PRELIMINARY BCA REVIEW

Glenhaven Gardens Expansion

Project_13253

DA ISSUE - 20TH APRIL_2017

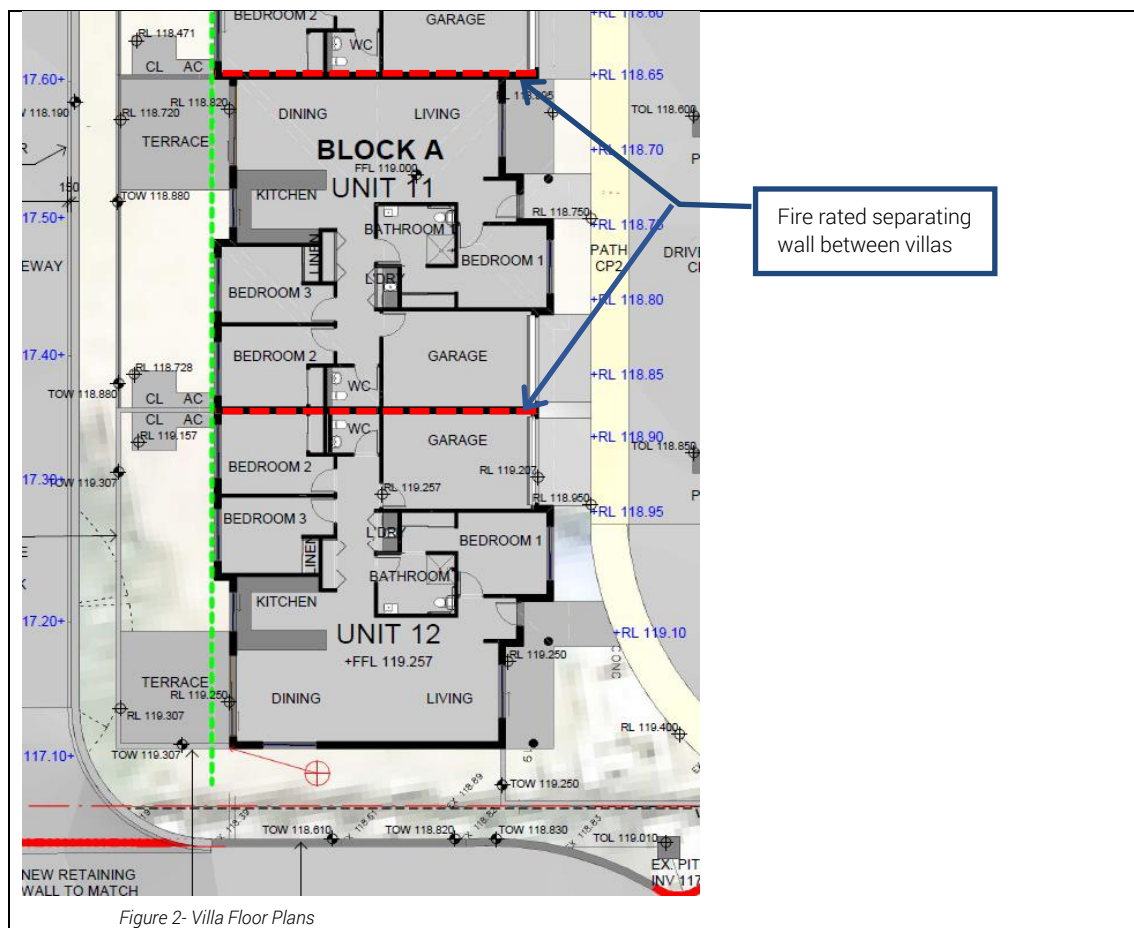
Part 3.7.1 of the BCA requires that the external walls of buildings are to be set back at least 900mm from site boundaries and 1800mm from another buildings on the same site, so as to prevent fire spread from one building to the next and for the protection of the neighbouring occupants.

Any walls closer than this are required to be fire protected.

Within the design all the Villas are set back more than 1m from the site boundaries and therefore meet the requirements of this clause.

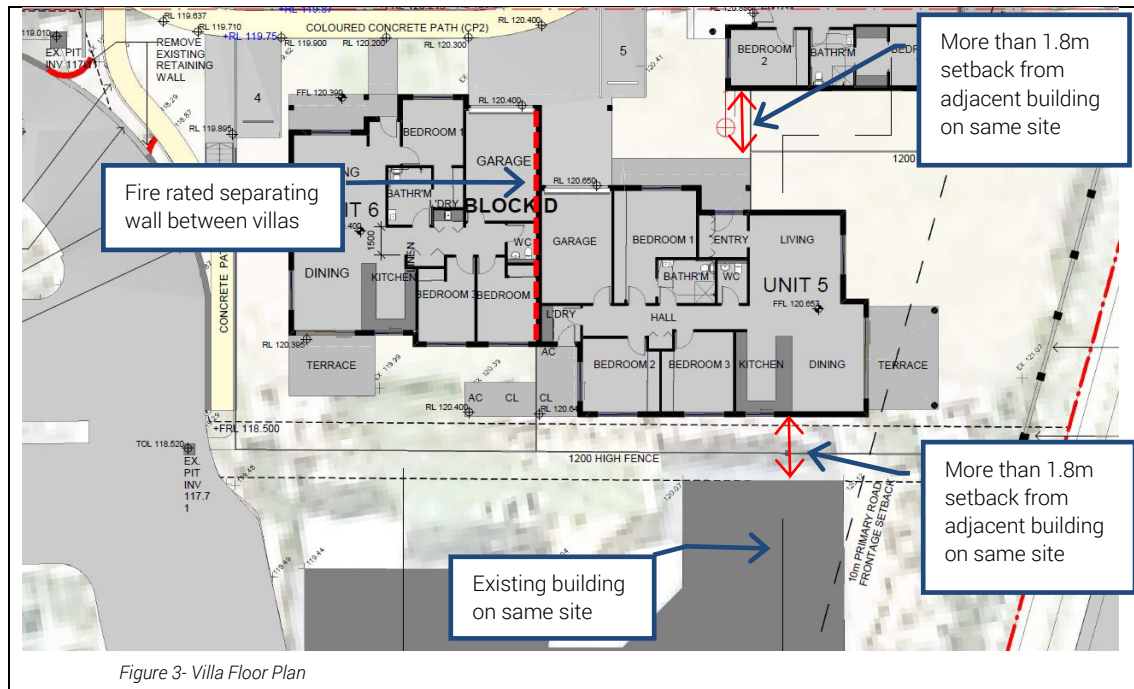
As each of the Villa are considered to be a separate Sole Occupancy Unit (class 1), separating walls are required between the villas.

Within the design the plans indicate a central wall between villas without any windows.

These walls are to be fire rated walls with an FRL of 60/60/60 and extend the full height of the building up to the underside of the roof lining if the roofing is non-combustible or 450mm above roofing if combustible. (required by Clause 3.7.1.8).

Note: only timber battens with a sectional area of 75mm x 50mm or less can cross the top of the wall.

If skylights are included within the villas they are to be set back at least 900mm from a site boundary or a fire wall separating two villas. (Clause 3.7.1.10)

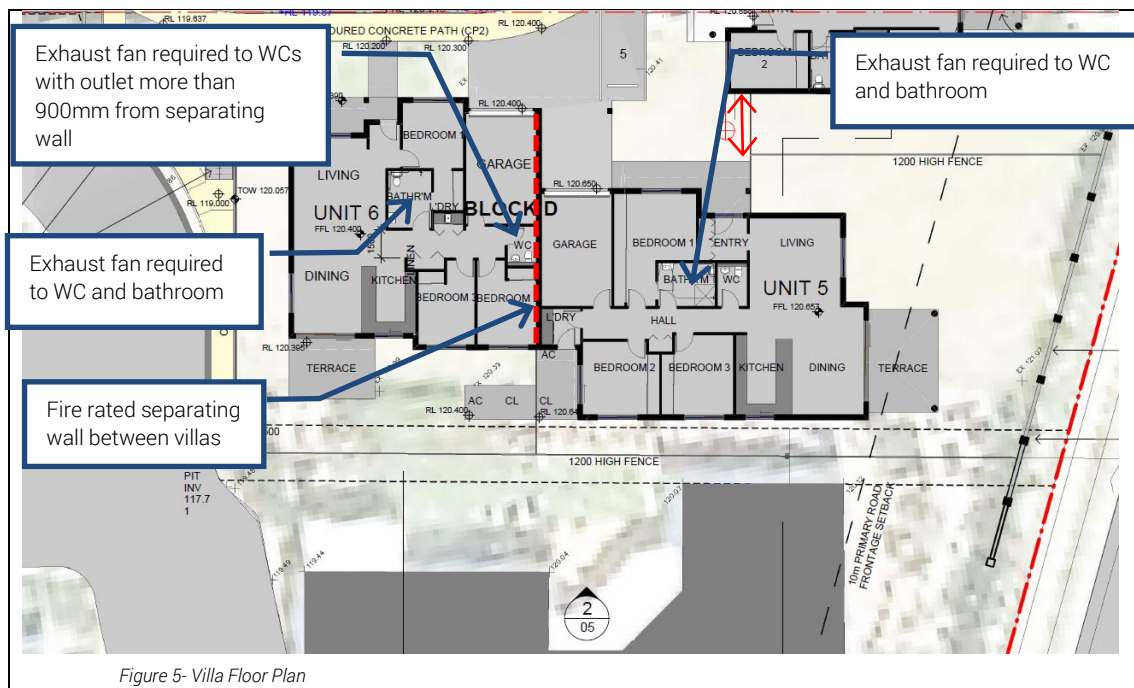
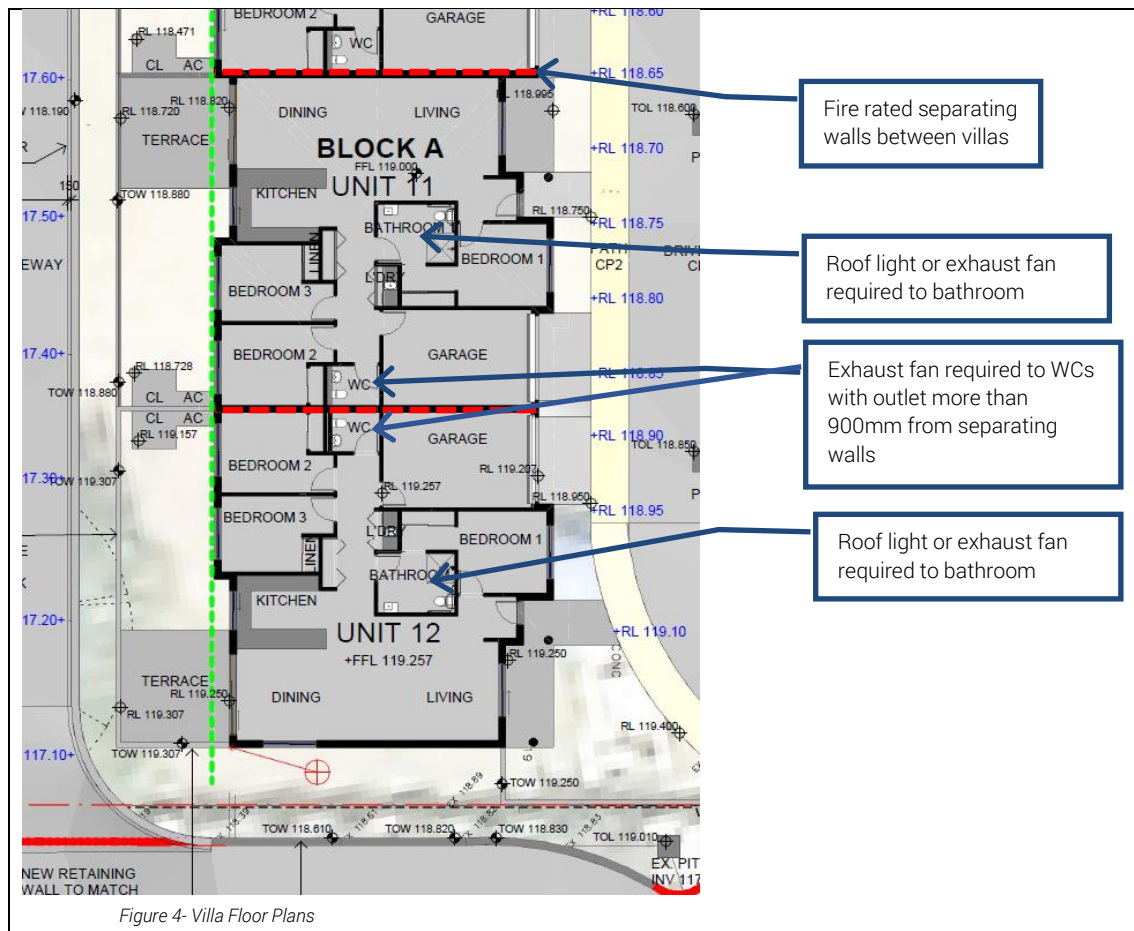
Within the design the habitable spaces have windows to meet the natural lighting requirements. These windows are to have 50% of the area as openable portions to provide the required ventilation. The wc's and a number of the bathrooms will require an exhaust fan to provide the required ventilation, as they are centrally located without windows.

Clause 3.8.5.3 requires that a sanitary compartment not open onto a kitchen or pantry unless the compartment is provided with an exhaust fan.

Within the design all the sanitary compartments are to be provided with an exhaust fan as they are located centrally, without an external window and located off a hall close to the kitchen area.
